PROJECT: Dexter Community Schools
New Fieldhouse Addition

RE: POST BID ADDENDUM 3

Date	April 23, 2026
Project Name	Dexter Community Schools – Dexter High School Field House
TMP Project No(s).	25026E
Design Release	Three (3)
Addendum No.	One (1)

2. Attached is an updated 2/C307 "Heavy Duty Bituminous Pavement" detail. This detail will be updated on the drawings in a future issuance.

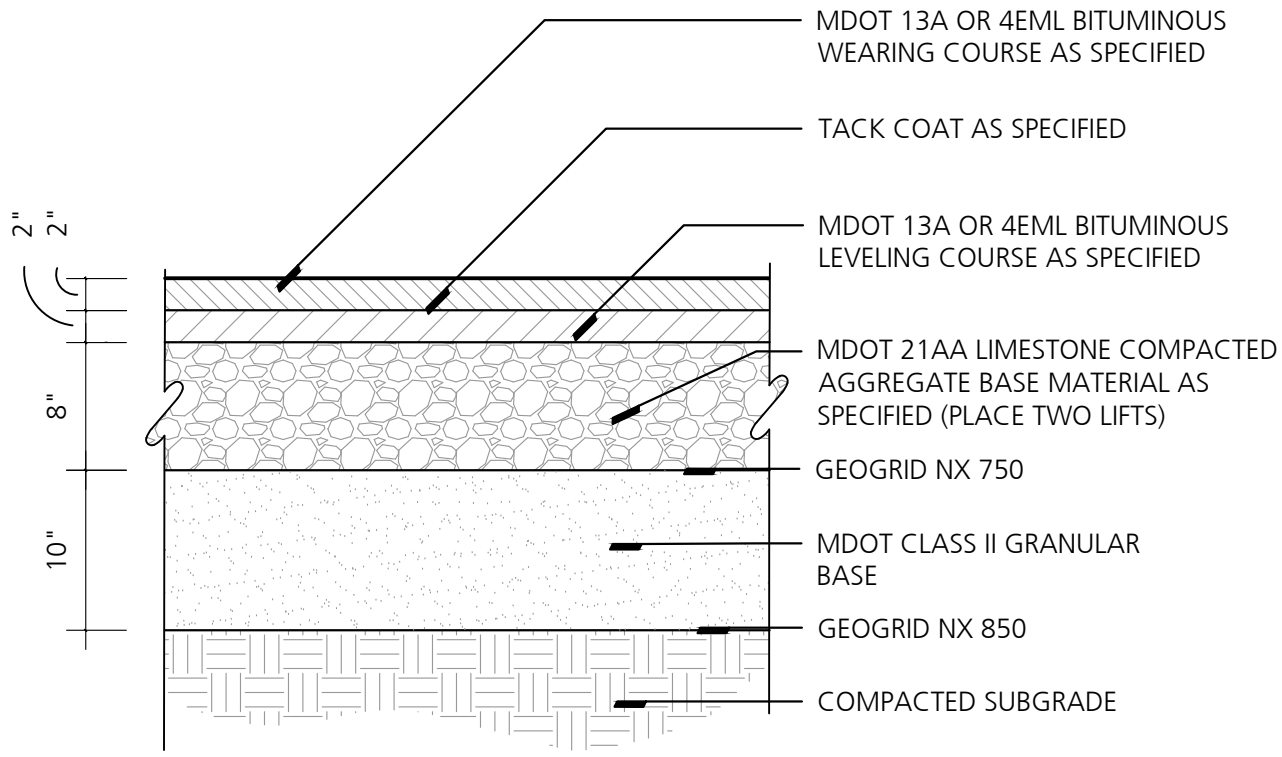
1. The current drawings show a 3" ductile domestic water service to the building. Is it ok to upsize this to 6"? 2. Detail 2/307 does not depict the dimension (thickness) of the sand subbase. Can you please provide this dimension? 3. Regarding detail 9/307 at the twin turf fields: Is the intention to remove the existing turf and then excavate the existing aggregate to achieve the cross-section for the new sidewalk? Can we assume that no new aggregate will need to be placed for the new sidewalk? All of this work is to be done while the existing netting poles remain in place?
